Amendments to the Drawings:

REMARKS/ARGUMENTS

In response to the Office Action of January 19, 2007, Applicant requests re-examination and reconsideration of this application for patent pursuant to 35 U.S.C. 132.

FIG 1A & FIG 1B

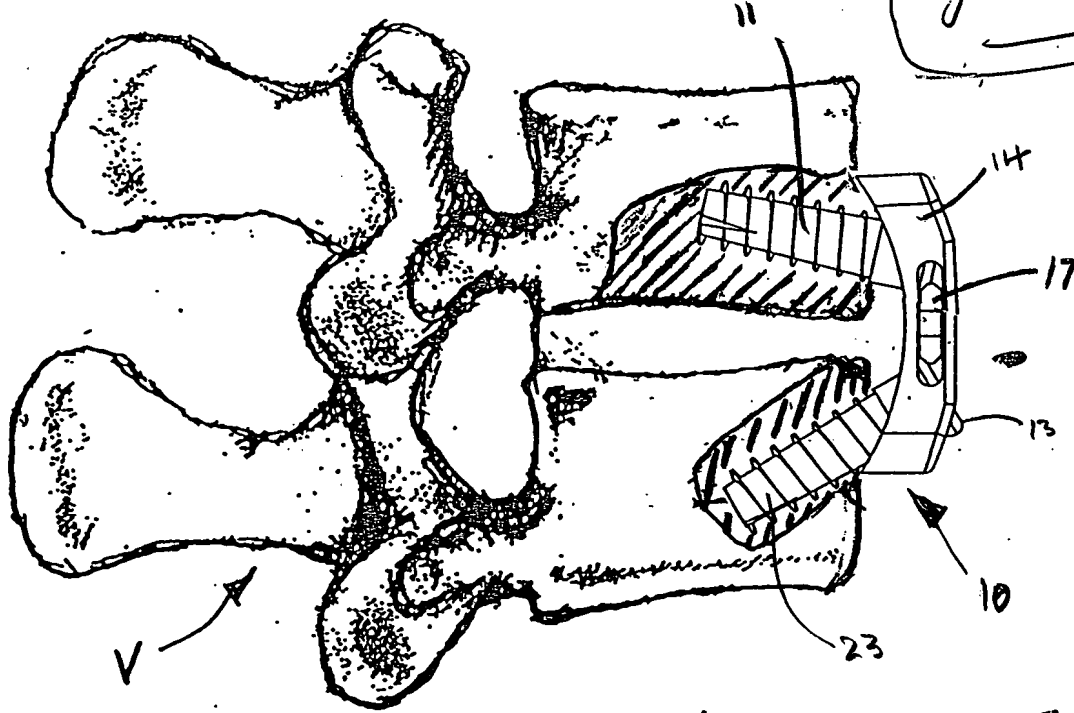
The attached sheet of drawings includes changes to Fig. 1. This sheet, which includes Fig. 1A-1B, replaces the original sheet. Figure 1A shows the plate in the correct orientation to the vertebra. Figure 1B has been added showing the plate in the orientation originally depicted in Figure 1, without a pictorial of the vertebra.

FIG. 2

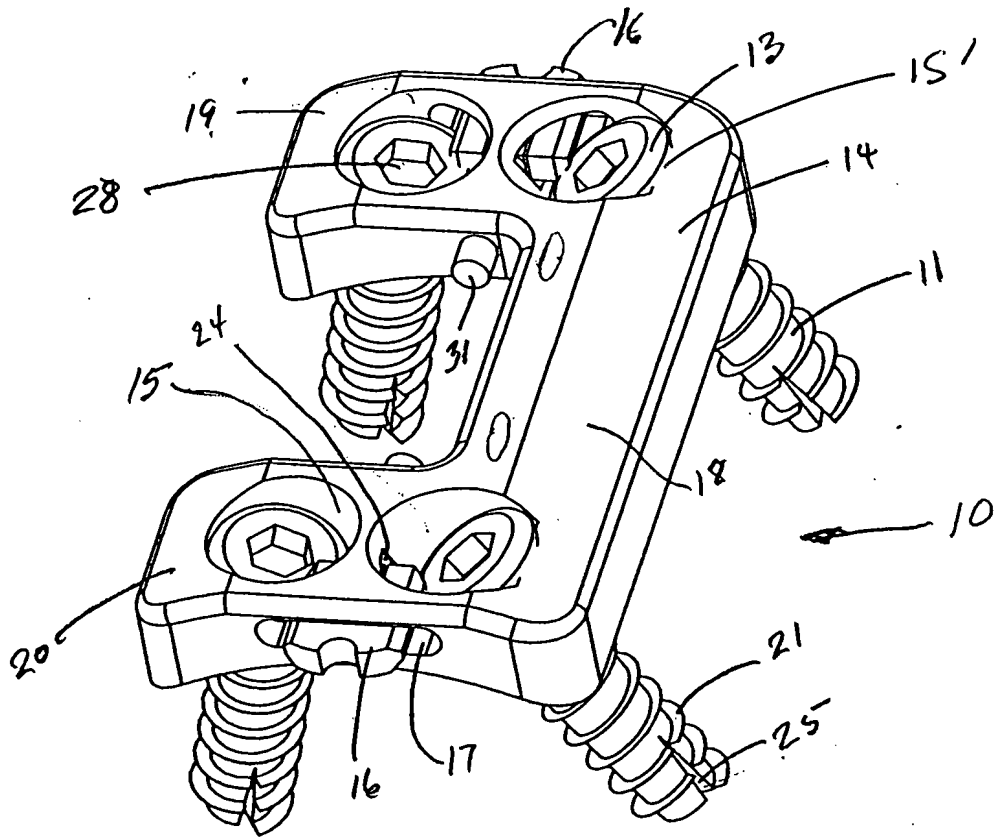
Figure 2 includes previously omitted element reference number 15' illustrating the location of the countersunk screw holes stated on page 5, line 19 of the specification.

FIG. 5

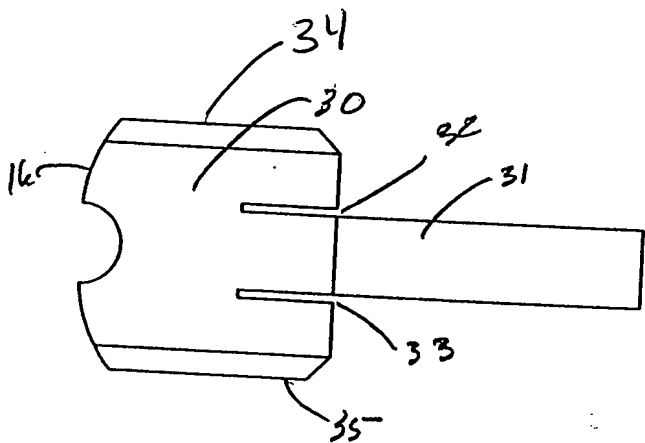
Figure 5 includes previously omitted element reference number 34 illustrating the location of the thinned edge stated on page 7, line 7.
